**Addendum No. 1**

Contract No.: 11421568  
TIP No.: N/A  
WBS No.: 1SP.10371.4, ETC.

*Construction of Secondary Containment Structures in Gates, Hertford and Hyde Counties*

1 FOUNDATION PLAN  
S1 SCALE: 1" = 10'-0"

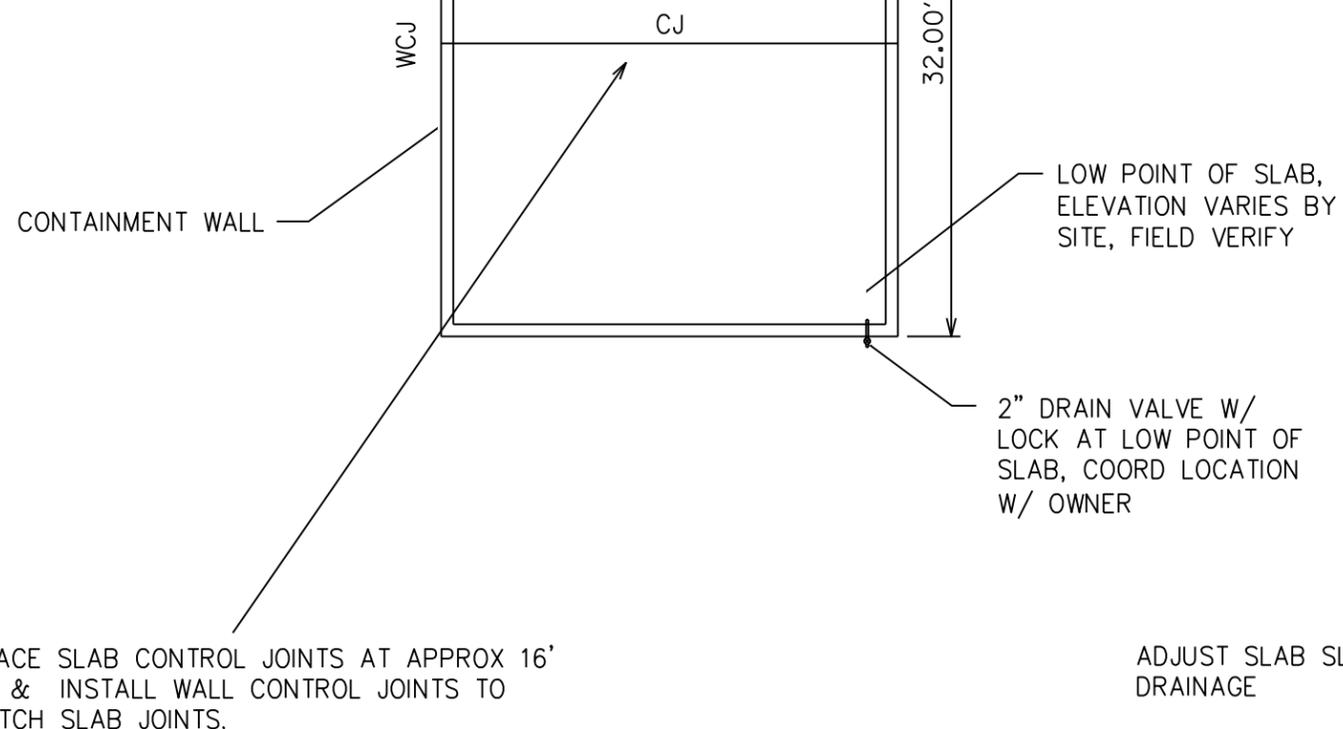
Plan Sheets have been revised to include a note that the Contractor shall be responsible for the excavation of all footings and to clarify the size of the drain valve with lock. Please void existing Plan Sheets and staple revised Plan Sheets thereto.

6" CONC SLAB REINF W/ EPOXY COATED #4 @ 12" EW ON 6" COMPACTED GRANULAR BASE  
(GRADING AND STONE WORK TO BE PERFORMED BY NCDOT)  
NOTE: CONTRACTOR WILL BE RESPONSIBLE FOR EXCAVATION OF FOOTER LOCATIONS

1 FOUNDATION PLAN  
S1 SCALE: 1" = 10'-0"

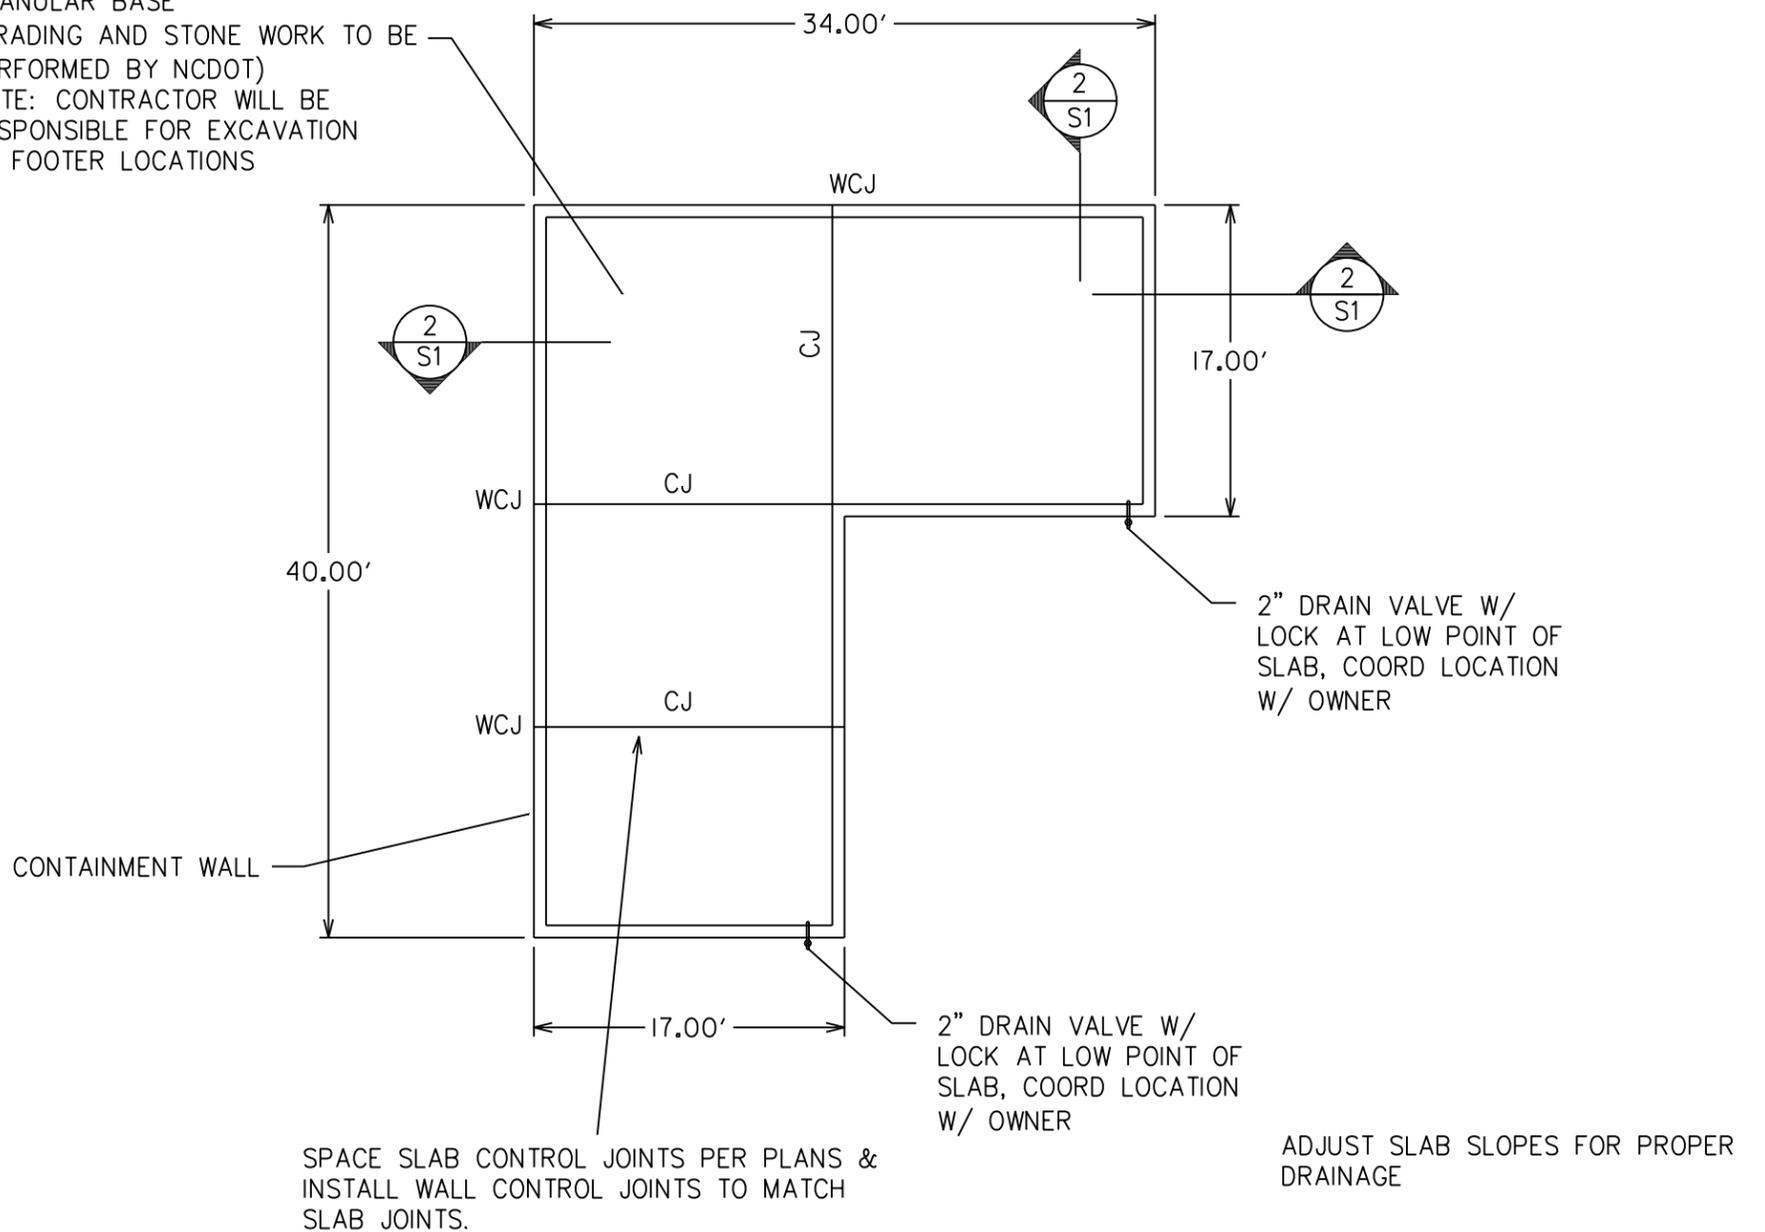
6" CONC SLAB REINF W/ EPOXY COATED #4 @ 12" EW ON 6" COMPACTED GRANULAR BASE  
(GRADING AND STONE WORK TO BE PERFORMED BY NCDOT)  
NOTE: CONTRACTOR WILL BE RESPONSIBLE FOR EXCAVATION OF FOOTER LOCATIONS

1 FOUNDATION PLAN  
S1 SCALE: 1" = 10'-0"

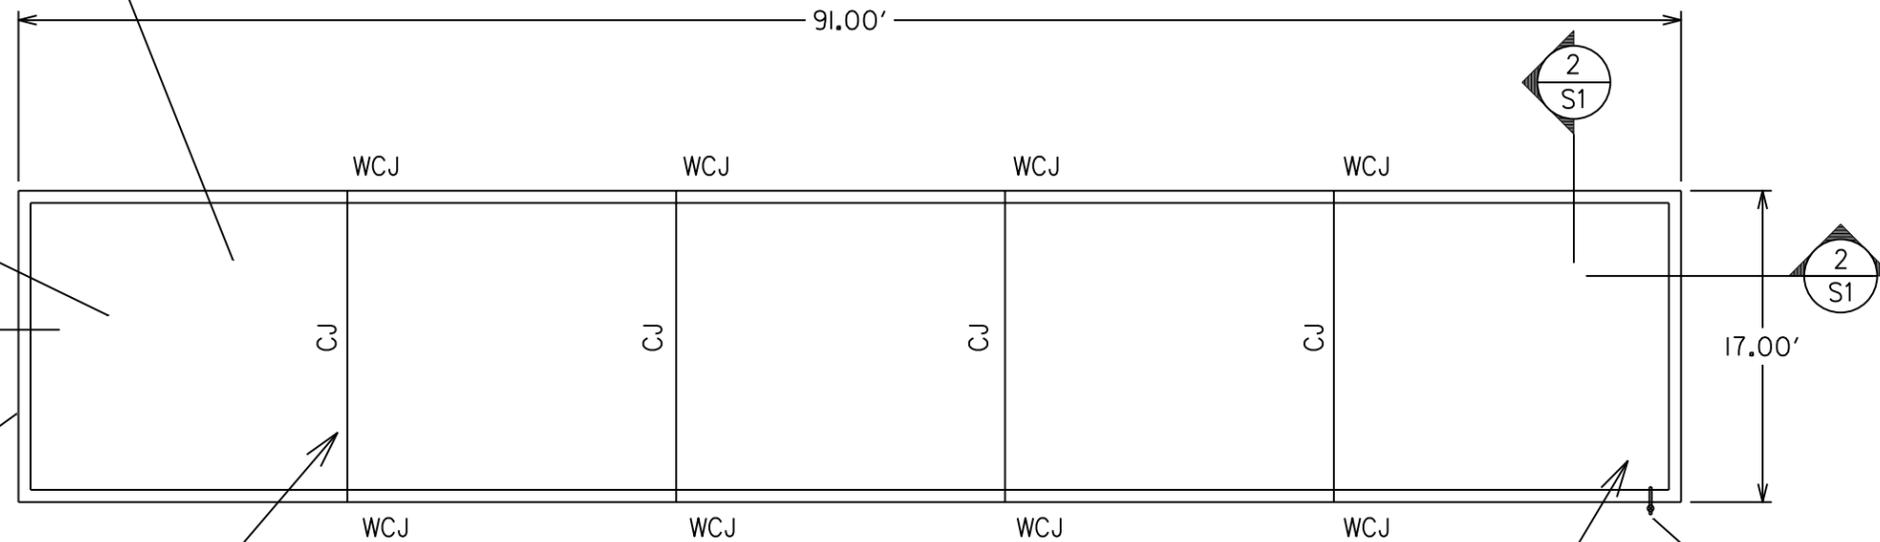
6" CONC SLAB REINF W/ EPOXY COATED  
#4 @ 12" EW ON 6" COMPACTED  
GRANULAR BASE  
(GRADING AND STONE WORK TO BE  
PERFORMED BY NCDOT)  
NOTE: CONTRACTOR WILL  
BE RESPONSIBLE FOR  
EXCAVATION OF FOOTER  
LOCATIONS

2" DRAIN VALVE W/  
LOCK AT LOW POINT OF  
SLAB, COORD LOCATION  
W/ OWNER
